**AGENDA**  
**VIRTUAL BIRMINGHAM DESIGN REVIEW BOARD MEETING**  
**WEDNESDAY – March 17<sup>th</sup>, 2021**  
**\*\*\*\*\* 7:15 PM\*\*\*\*\***

# MEMORANDUM

**SUBJECT:** 1050 Webster – Design Review

PROPOSED ELEVATION

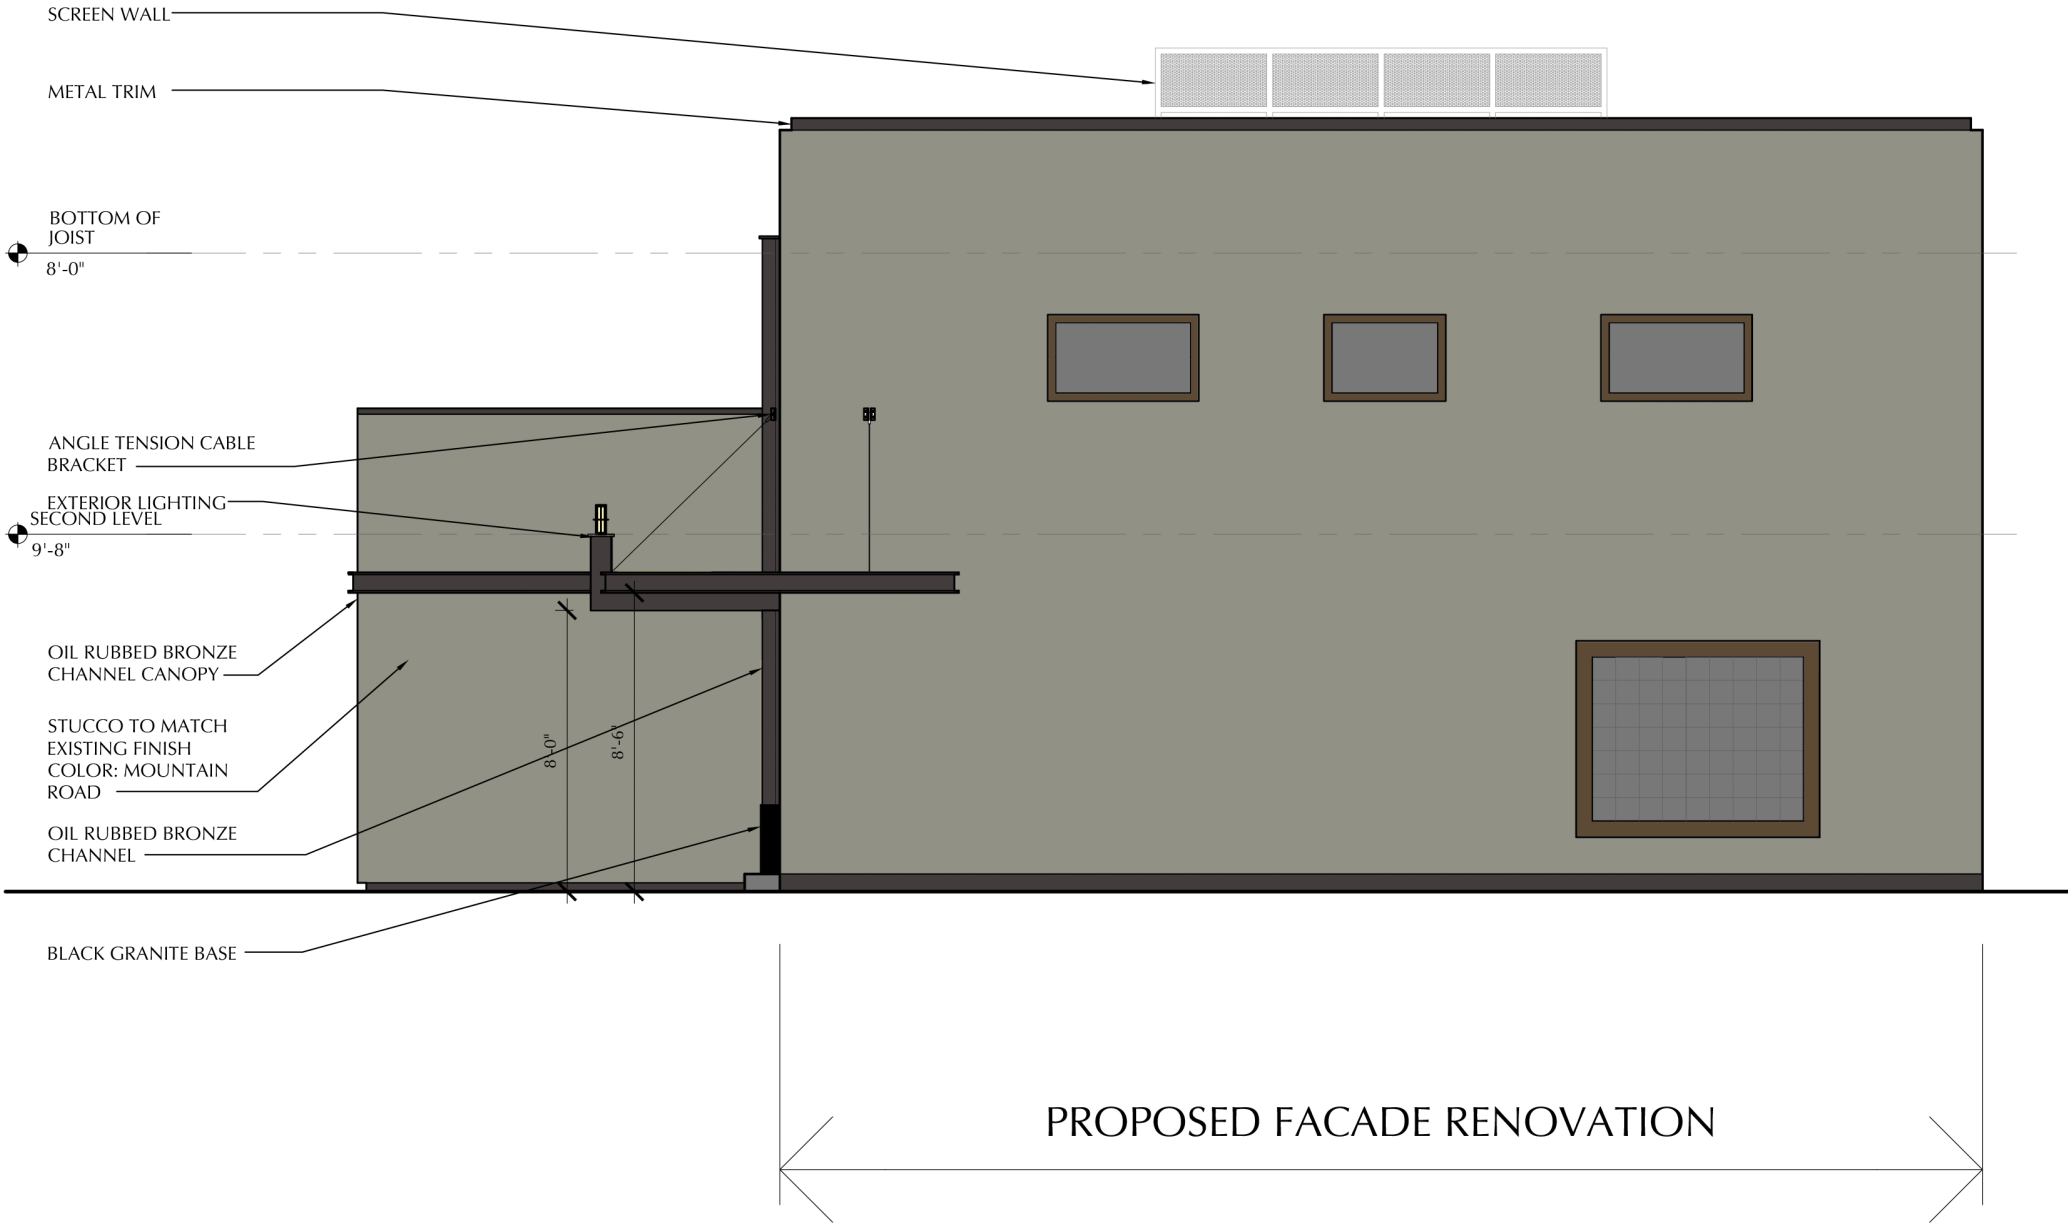
**The applicant must submit revised elevations with color/material details for all newly proposed materials.**

**Screening:** As noted above, the applicant is proposing to install a new screenwall system on the roof. At this time, it is unclear as to whether this is being built to screen new rooftop mechanical units, or to screen existing mechanical units (no roof plan has been submitted). **The applicant must clarify the intent of the new rooftop screenwall.**

At this time, the applicant has not submitted glazing calculations or specification sheets for the newly proposed glazing. **The applicant must submit glazing calculations and specification sheets for all new glazing.**

1. The applicant must submit revised elevations with color/material details for all newly proposed materials and light fixtures;
2. The applicant must clarify the intent of the new rooftop screenwall; and

3. The applicant must submit glazing calculations and specification sheets for all new glazing.
